**Re: GE-Pittsfield/Housatonic River Site  
Hill 78 Area-Remainder (GEC160)  
Final RD/RA Work Plan**

**Final Removal Design/ Removal Action  
Work Plan for Hill 78 Area-Remainder**

**Final RD/RA Work Plan**

Hill 78 Area-Remainder

Revised Table B-21 and  
Figure B-33

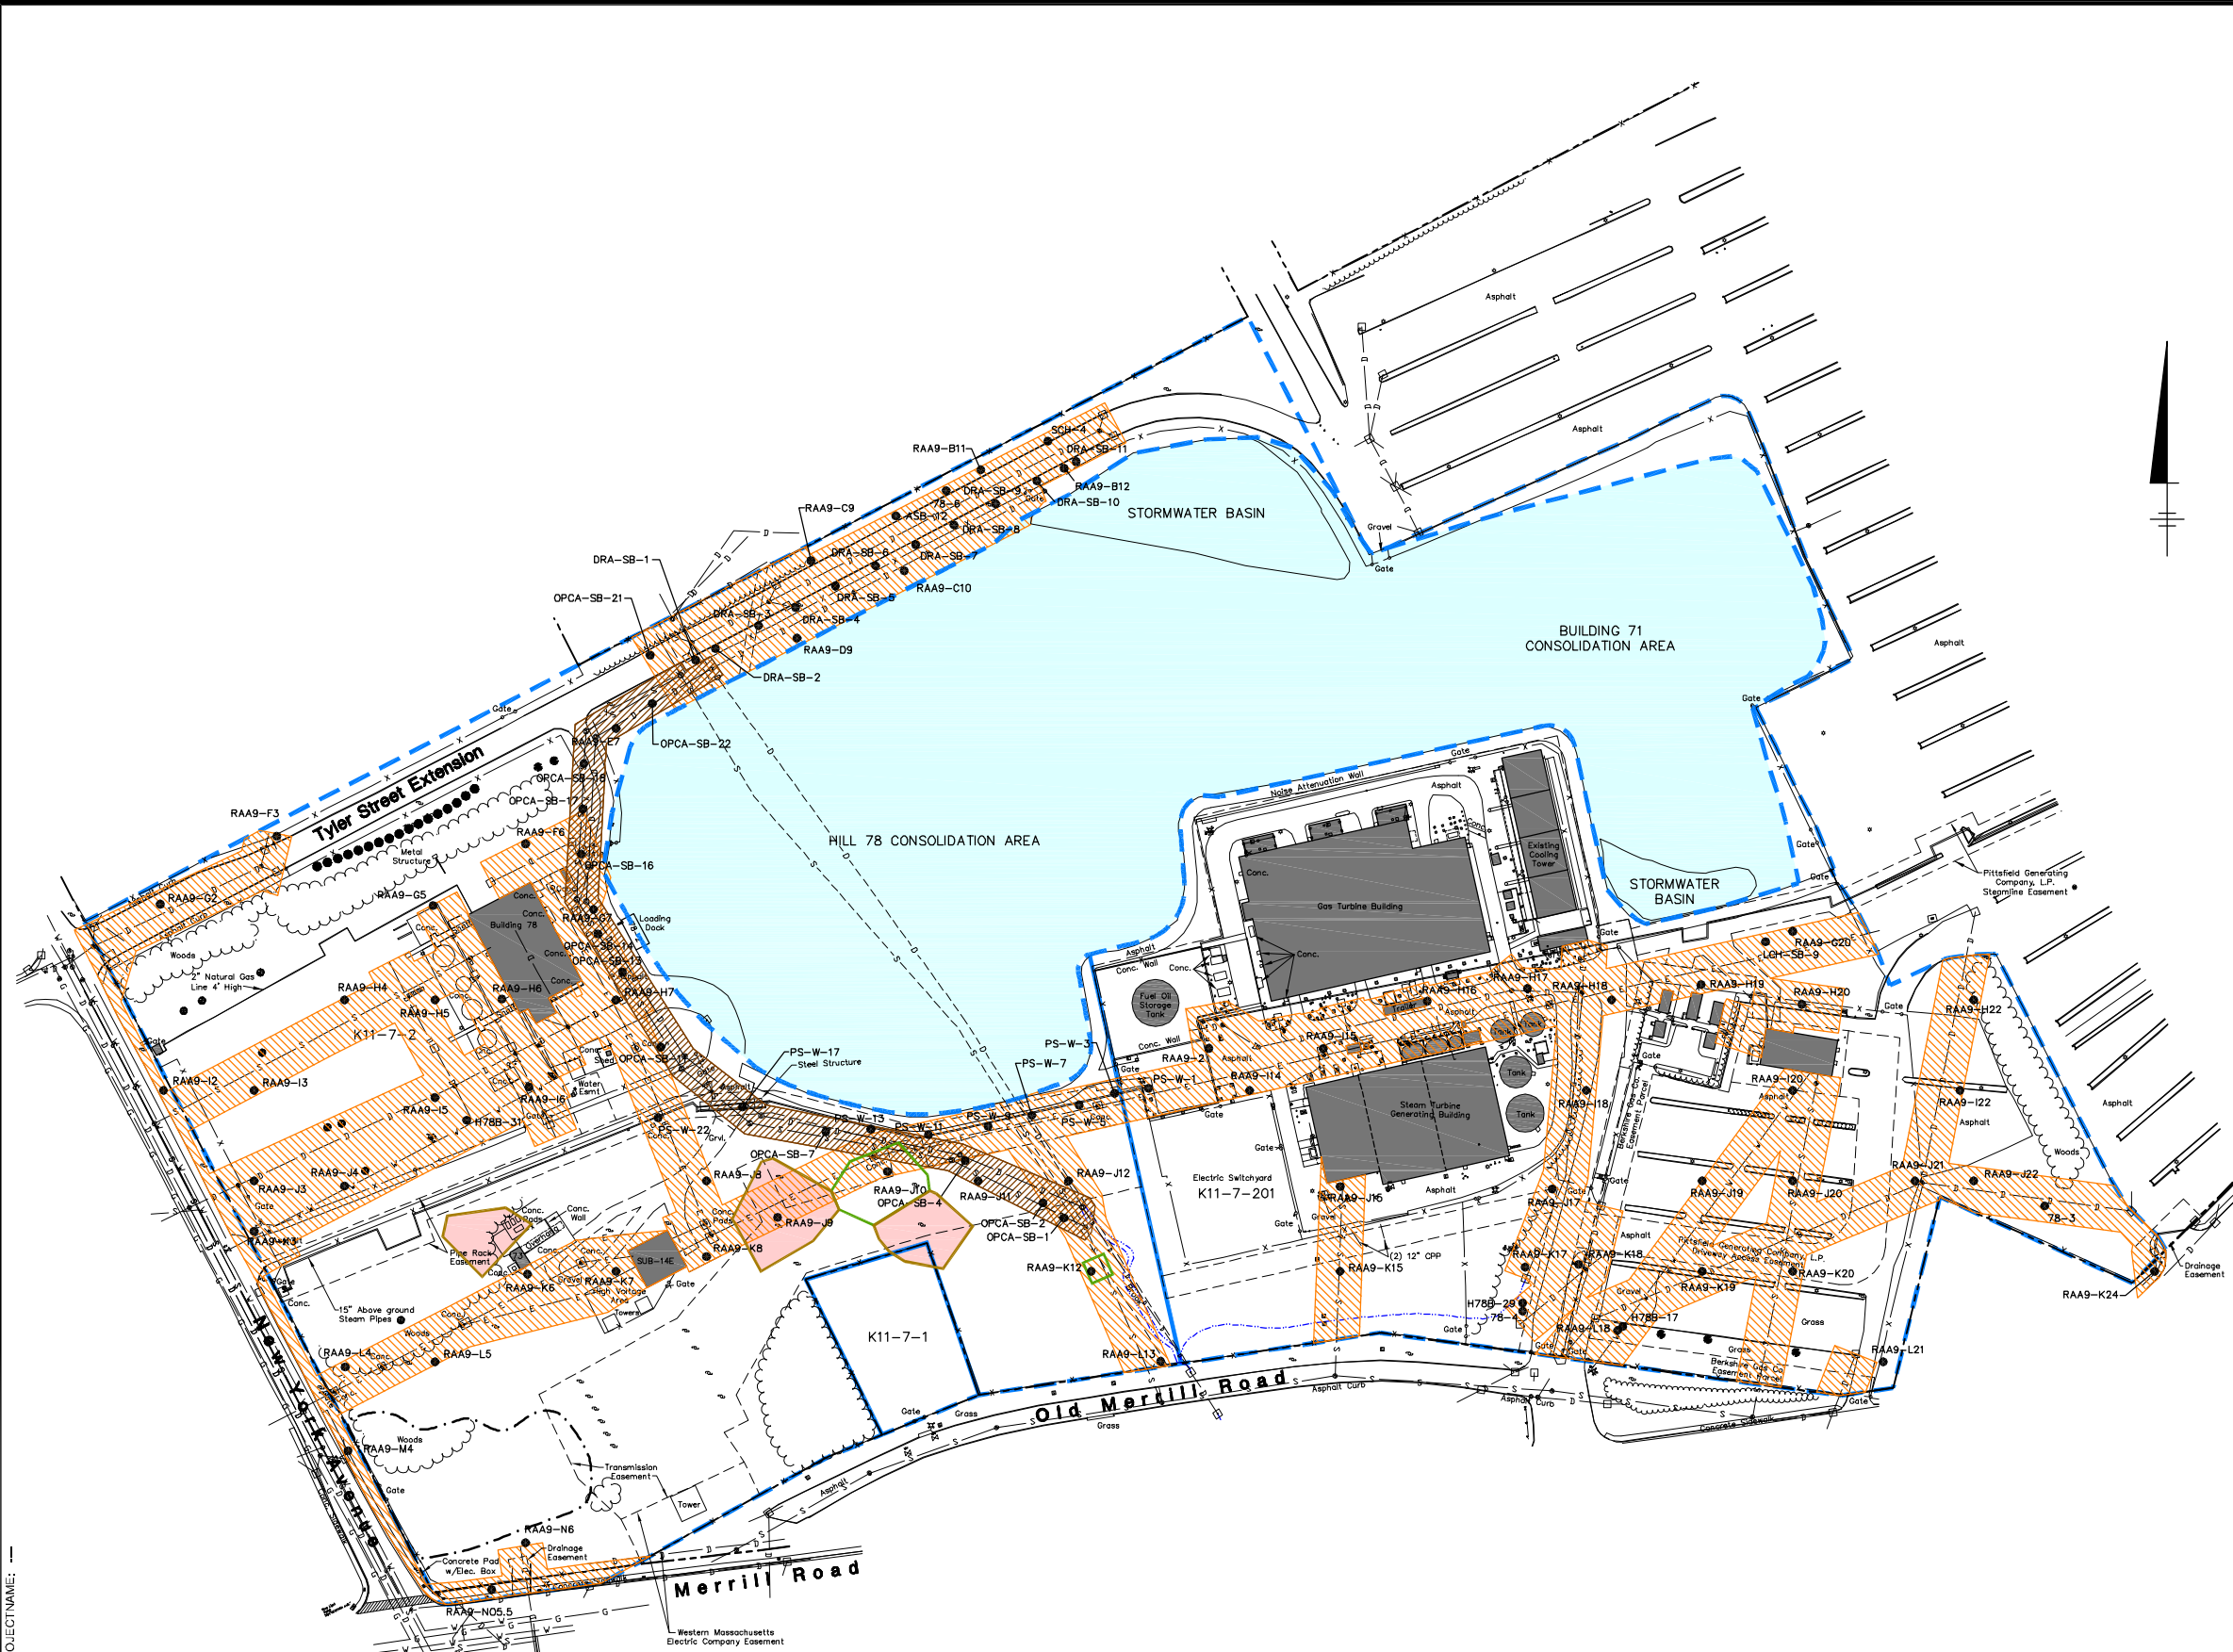
*EPA Comment 6: GE shall revise Figure B-33 to include the soil sample locations within the realigned storm and sanitary sewer corridor and table B-21 to include the analytical results for these soil samples.*

*EPA Comment 7: GE shall revise Figure B-33 to correctly represent utility corridors and address any discrepancies between this figure and Figure 1 of GE's July 27, 2007, Hill 78 Area-Remainder Third Supplemental Data Letter. Specifically, GE shall review, and if necessary, adjust the utility corridors in the vicinity of grid transect N7, along Tyler Street Extension, and in the vicinity of grid transect I7 along the south side of the RAA boundary.*

GE Response: Revised versions of Figure B-33 and Table B-21 are included in Attachment A.

GE Response: Based on a review of the above-referenced drawing, a revised Figure B-33 is included in Attachment A. As indicated above, the revised Table B-21 includes the relevant PCB analytical results associated with the corridors shown on Figure B-33. GE notes that Figure 1 of the Third Supplemental Data Letter inadvertently showed in cross-hatching certain areas with no utilities present, and GE has corrected these errors in the attached Figure B-33.
